Change Order No. 1

Date of Issuance: 7/8/2020	Effective Date:
Owner: City of Lafayette	Contractor: Rieth Riley
Engineer: HWC Engineering	Project: Lafayette Streetscape Phase III

You are hereby directed to make the following changes to the project scope of work as directed in the contract plans and specifications, reflecting subsequent additions and/or deductions to your contract amount and contract completion date: **Item # 36 Change to Str. 411 : Furnish / Install 1 EACH – Manhole, C2 in lieu of the planned : 1 EACH – Inlet, J10 ; Item # 40 Bollard Post, Alley, Install Only ; Item # 41 Bike Rack, Install Only ; Item # 42 Detectable Warning Surface, Tuftile Radial Plates ; Item # 43 Rain Garden Outlet to Storm Sewer ; Item # 44 Sanitary Work 10th St. ; Item # 45 Tree Trimming N. 10th St. ; Item # 46 Decorative Fence, SE corner 10th / Main ; Item # 47 Enlarge Fleur De Lis Logos**

Structure ID:411

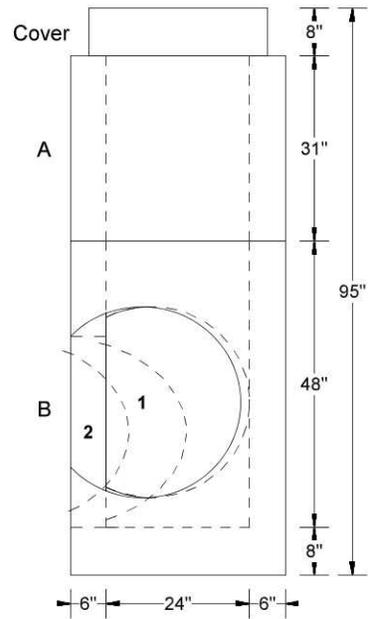
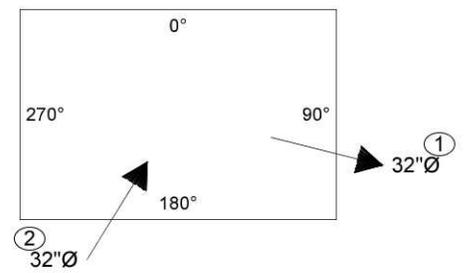
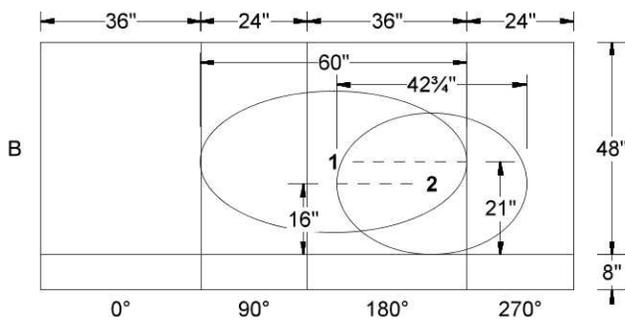
Will need to change the structure to what works. Manhole C-2, H-2, etc.

***** Structure will not work due to pipe conflict.*****
